P.P.D (Regularization NO : 179
L.O 2017) 2020

VIDE LETTER NO : Reg.L /4324/ 2020
DATE : /06/ 2020

IN-PRINCIPLE APPROVAL OF LAYOUT FRAMEWORK IN S.NO:762/4 OF KORATTUR VILLAGE, GREATER CHENNAI CORPORATION AS PER G.O.(Ms) No:78 H&UD UD4 (3) DEPT. DT:04.05.2017 AND G.O.(Ms) No:172 H&UD UD4 (3) DEPT. DT:13.10.2017 AND OFFICE ORDER NO.15/2018 DT: 12.12.2018.

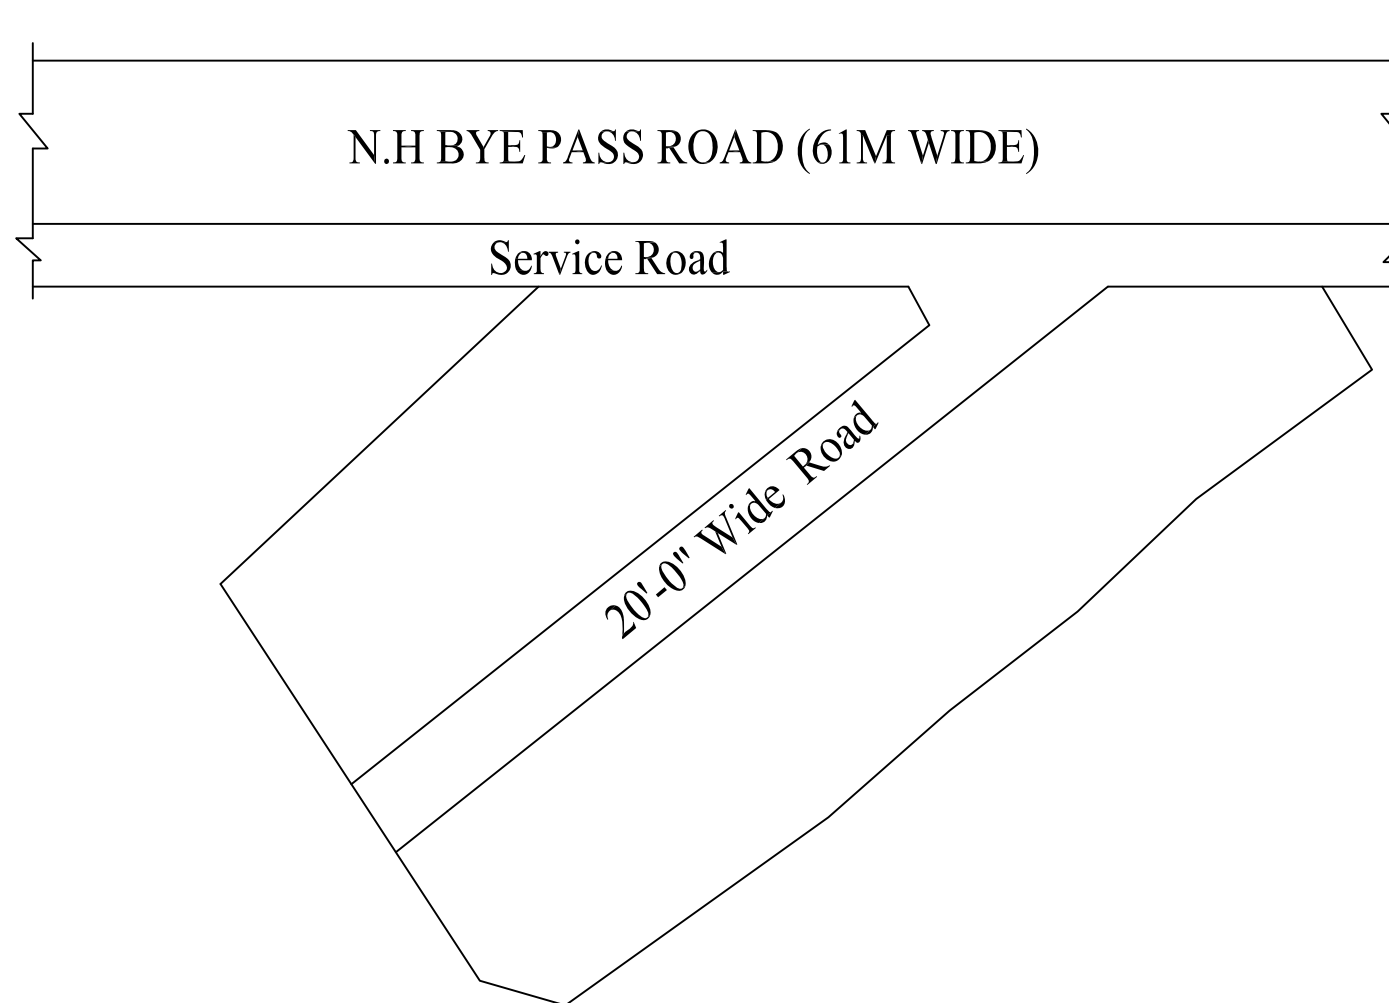
- 8) Ambattur - Puzhal road passes through the S.No.762 of Korattur Village. Street Alignment is prescribed 24m. GCC has to ensure the provision of street alignment before regularizing the individual plot in the layout under reference.

- 9) As per Second Master Plan for Chennai Metropolitan Area the street alignment of NH Bye-Pass Road is 61.0Mt. The street alignment will be provided by the individual plot owners as per the provision of Second Master Plan. GCC shall ensure the street alignment has been provided as per the provision of Master Plan before regularizing the individual plot.

- 10)The Regularisation of layout site was inspected by GCC and forwarded to CMDA with recommendation to accord framework approval. The Shape and dimension of the layout framework is based on the sketch furnished by the applicant which was forwarded by GCC to CMDA. Hence any variation in the dimension and extent has to sorted out with respect to the FMB of the site by GCC and the applicant. Further connectivity of layout to the public road and internal road pattern shall be ensured by the GCC before issuing final approval.
